# **Russell Gap Stream Mitigation Project Year 1 (2020) Monitoring Report FINAL**

DMS Project ID No. 100003, DEQ Contract No. 6980

**Subject:** Response to DMS Comments for DRAFT MY1 Report  
Russell Gap Mitigation Project, Alexander County  
DMS Project # 100003, DEQ Contract #6980, Catawba River Basin

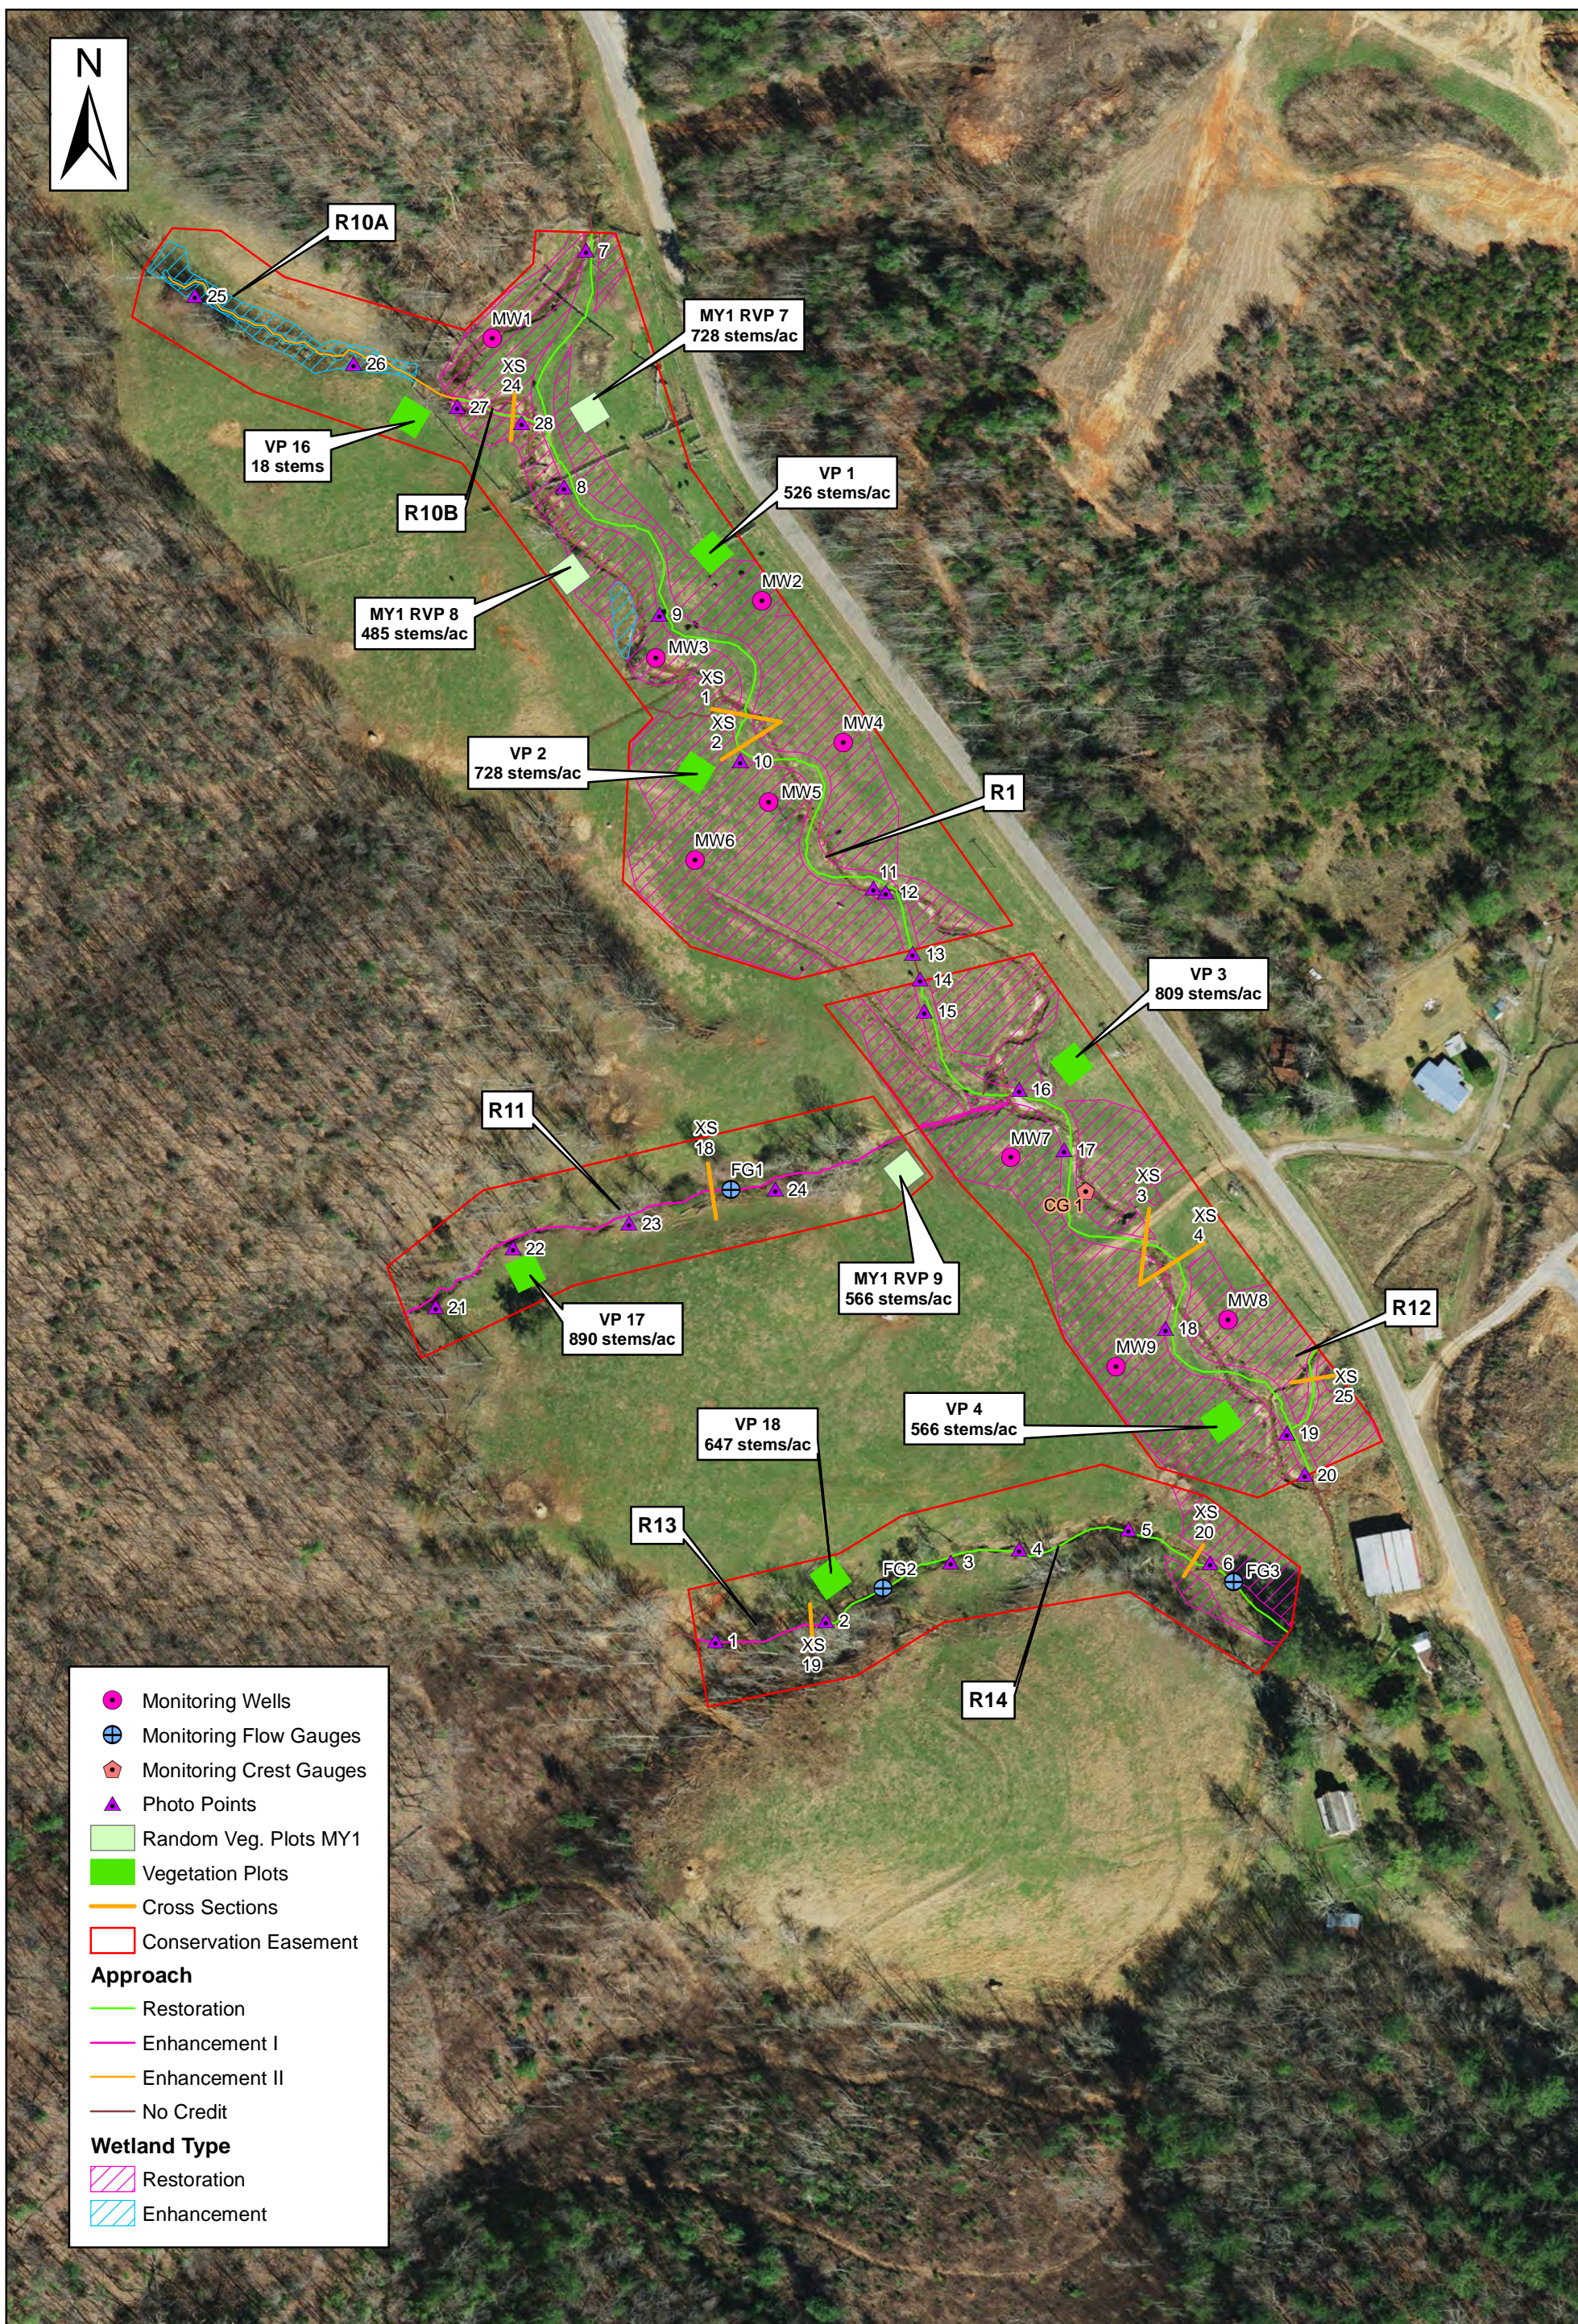
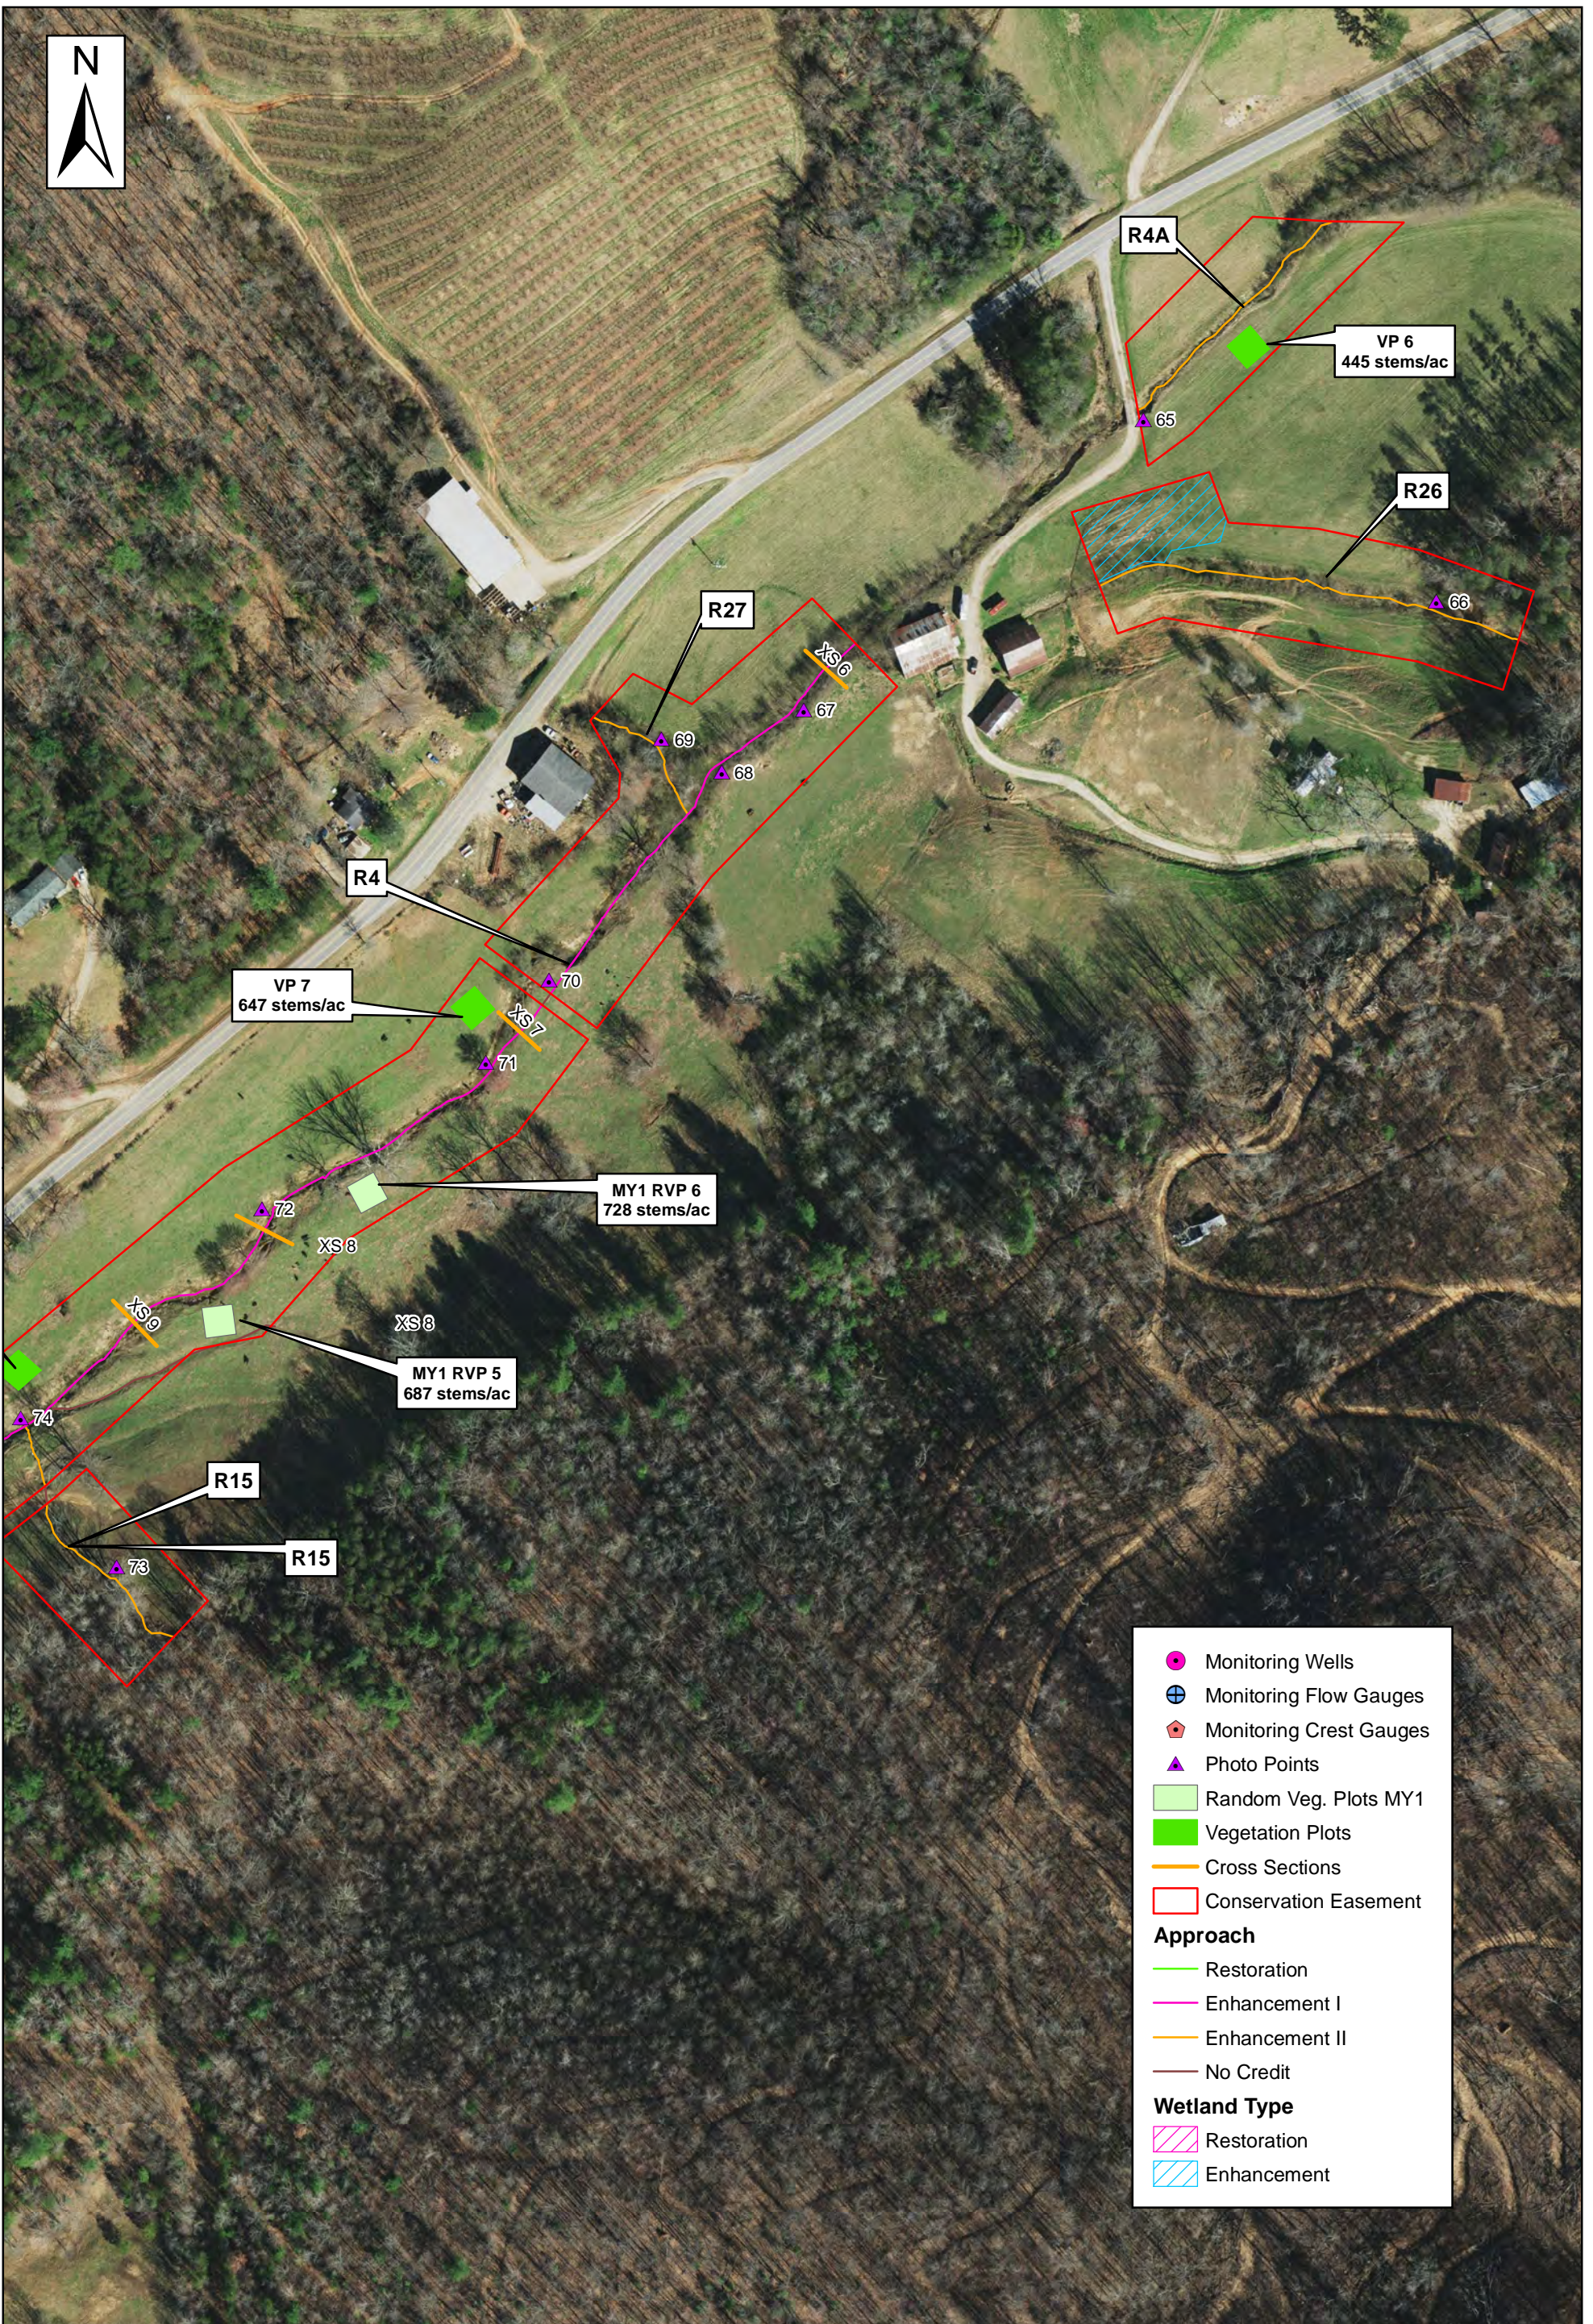
**Response: Revision made as requested.**
- CCPV: Previous Random Veg Plots are shown on the CCPV. Please turn off and only show the Random Plots from MY1.

**Response: Revision made as requested.**
- Table 5: All streams are functioning at 100% based on the metrics measured by Table 5. This is impressive for a site of this size and considering the numerous storm events the region experienced this year. This will likely raise questions during the 2021 Credit Release Meeting. Please be prepared to discuss this at the meeting.
